REMARKS

Drawings and Specification

FIG. 2

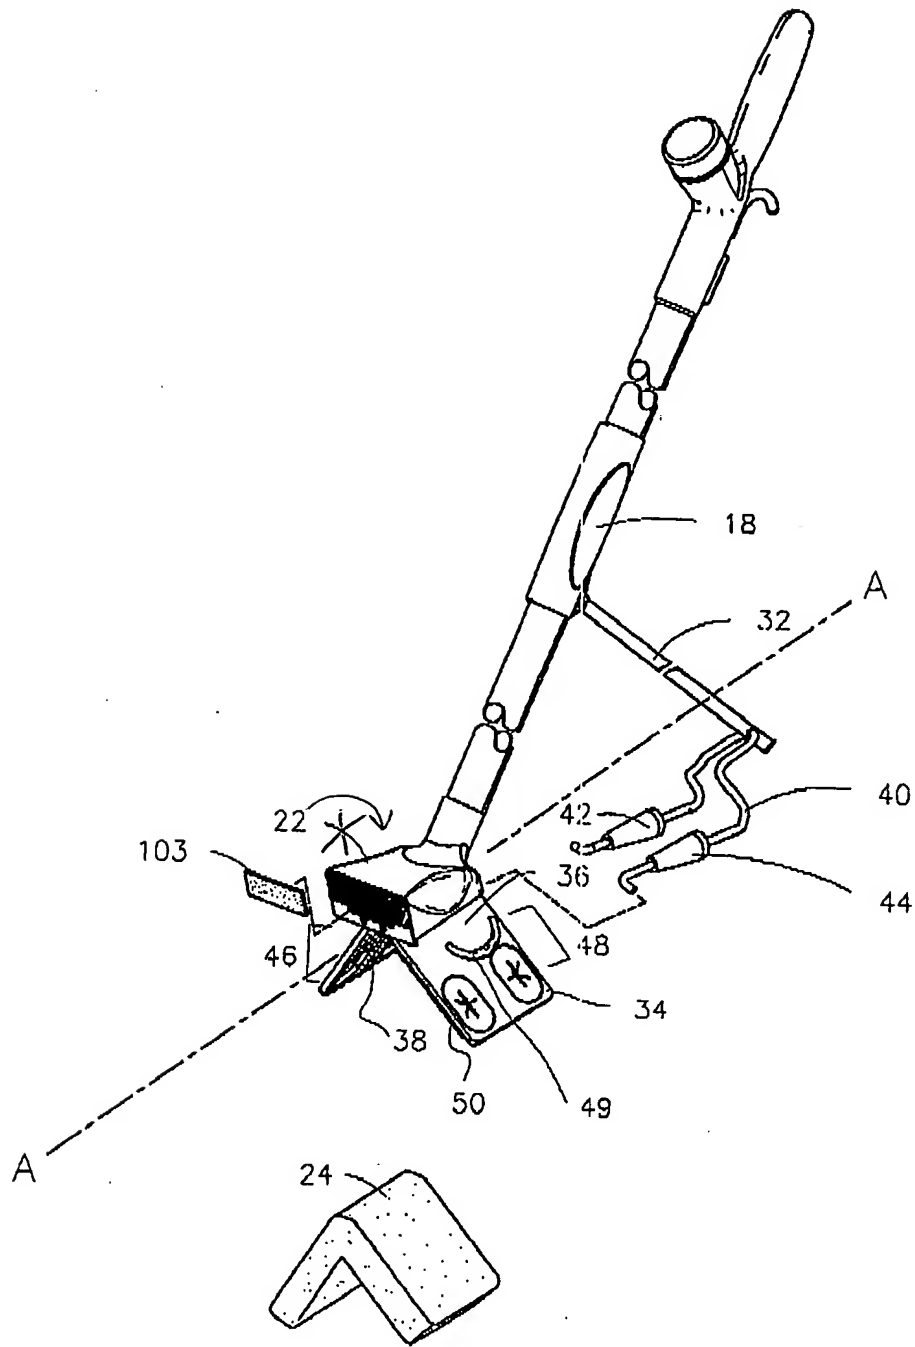
The drawings stand objected to because (1) in Fig. 2, the lead line for 22 is allegedly misdirected, (2) in Fig. 3, the small piece in front of 28 is unidentified and (3) with respect to Fig. 5(a), reference character 162 is not mentioned in the specification. Corrected drawing sheets in compliance with 37 C.F.R. § 1.121(d) are filed herewith.
